Campaign No. 2020100015, November 2020  
Revision A

SUBJECT: **Model GLE-Class and GLS-Class vehicles (167 platform)**  
**Model Year 2020**  
**Installation of the Illuminate Star**

Figure 1

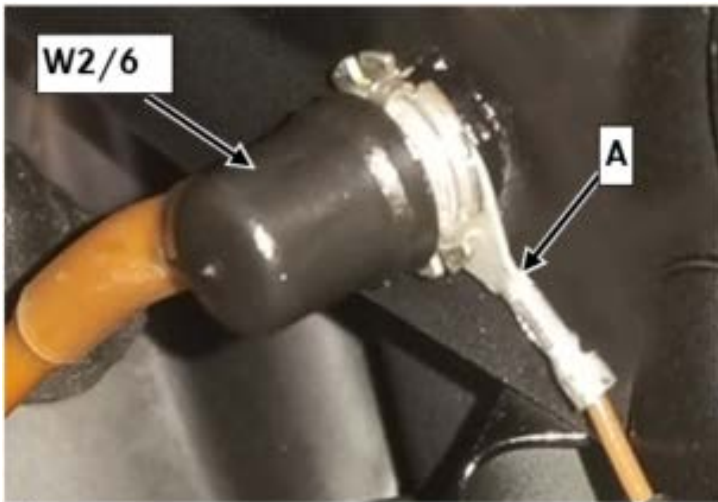
1. Open hood.
2. Switch off ignition and store transmitter key outside the transmitter range (at least 2 meters).
3. Unscrew ground **point W2/6**.  
i For basic data, see **GF00.19-P-2001-17NCA**.
4. Remove illuminated star ground line (**A, figure 1**).

- Check ground line clearance.
- Ground line may be zip tied to shorten original length.
- Check behind the illuminated star for any possible zip ties around the ground wire.
- Zip ties may be removed for extra length if needed.

6. Route illuminated star ground line (**A, figure 1**) to jump-start connection point and attach to threaded pin of jump-start connection point.
7. Screw on brass sleeve (**B, figure 2**).  
**Hm** Brass sleeve 16 Nm.
8. Secure illuminated star ground line (**A, figure 1**) up to jump-start connection point.  
**i** Ensure a chafe-free routing and attachment of the illuminated star ground line See **AZ88.40-P-0011-01ME**
9. Check anti-twist protection (**C, figure 3**) of cable lug of ground **point W2/6** for damage.

Figure 4

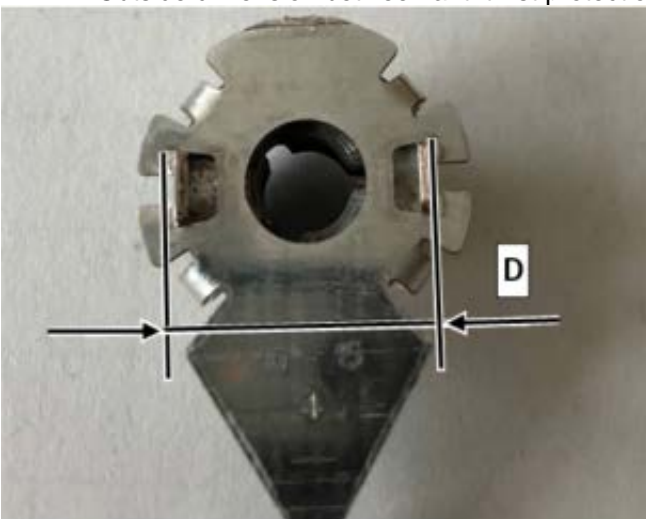
10. Measure outside dimension between anti-twist protection lugs (**D, figure 4**).

**i** Outside dimension between anti-twist protection lugs (**D, figure 4**) min. 13.6 mm.

- a. Anti-twist protection (**C, figure 3**) **straight** or **bent outwards**, i.e. outside dimension between anti-twist protection lugs (**D, figure 4**) **equal to or greater than 13.6 mm**: Perform operation step 11, then **end measure**.
- b. Anti-twist protection (**C, figure 3**) **bent inwards**, i.e. outside dimension between anti-twist protection lugs (**D, figure 4**) **less than 13.6 mm**: Create **PTSS case**.

**i** Only if anti-twist protection of cable lug is **bent inwards** , i.e. outside dimension between anti-twist protection lugs (**D, figure 4**) is **less than 13.6 mm**.
